SERVICE LETTER

No. 798

Piper Aircraft Corporation

Subject: Cabin Headliner/Oxygen Cover Panel Refinement

OXYGEN COVER PANEL REWORK

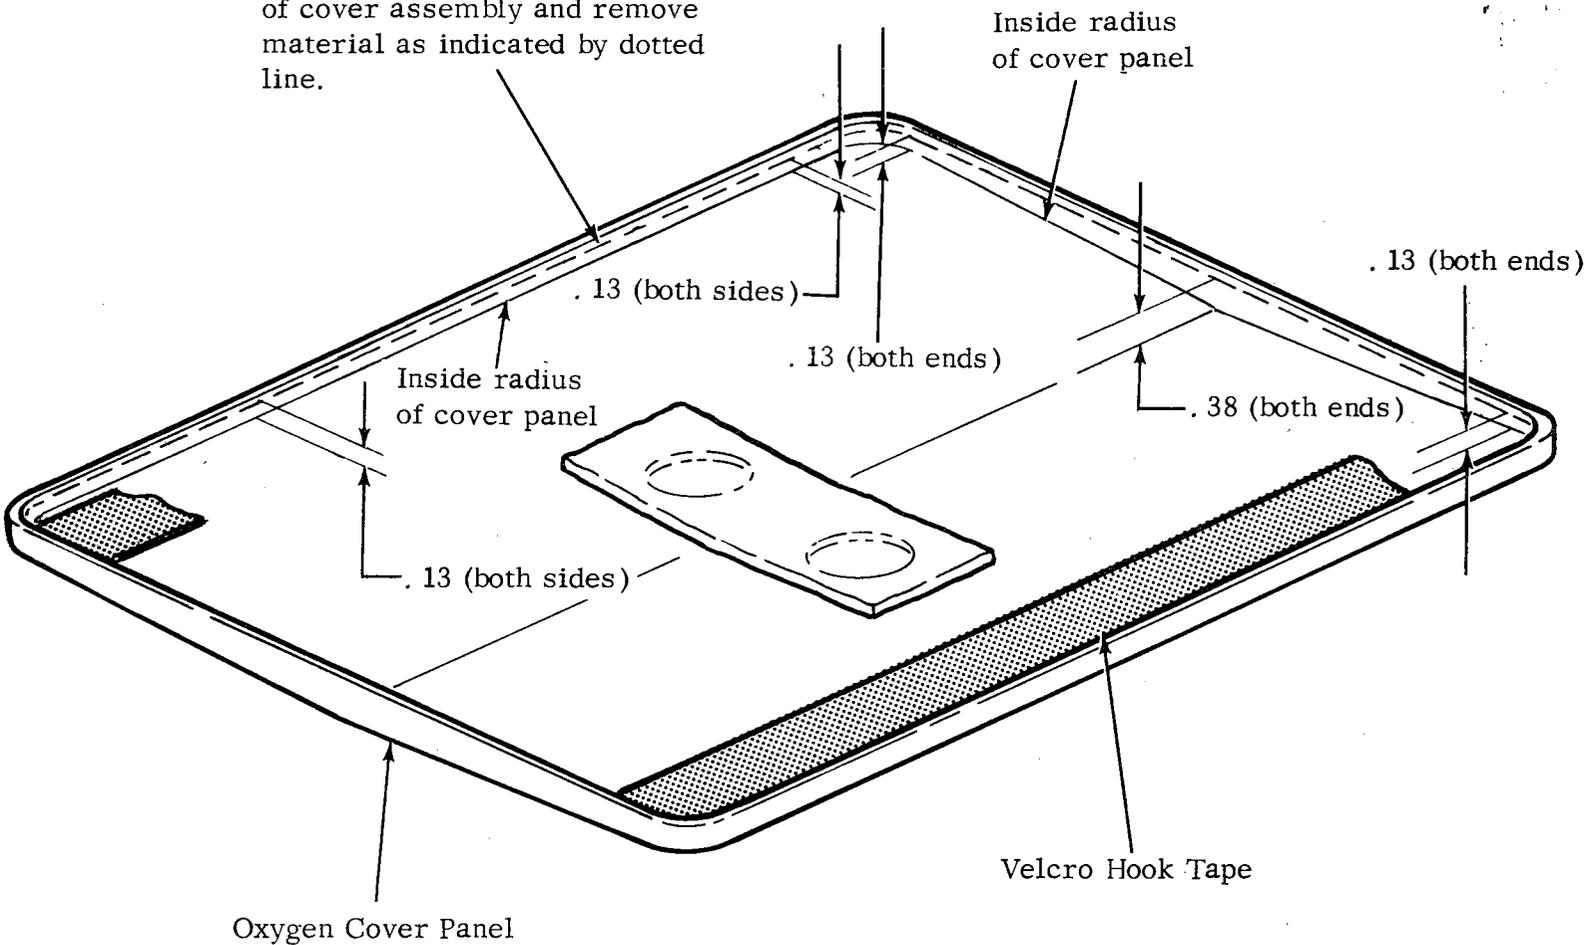
Purpose: Several customer acceptance reports received from Pressurized Navajo and/or Cheyenne owner/operators indicate that the oxygen mask storage cover panels do not fit properly with respect to the cabin center headliner, presenting an undesirable appearance. This may exist as a result of excessive cover panel covering material.

Scribe line along inside flanges of cover assembly and remove material as indicated by dotted line.

1. Remove the three oxygen cover panels from the headliner center panel assembly.
2. Scribe a line, to dimensions shown above, along the inside flanges of the cover assemblies.
3. Remove excess material using the most convenient method.
4. Reinstall cover panels to headliner center panel assembly.
5. Make proper logbook entry of Service Letter compliance.
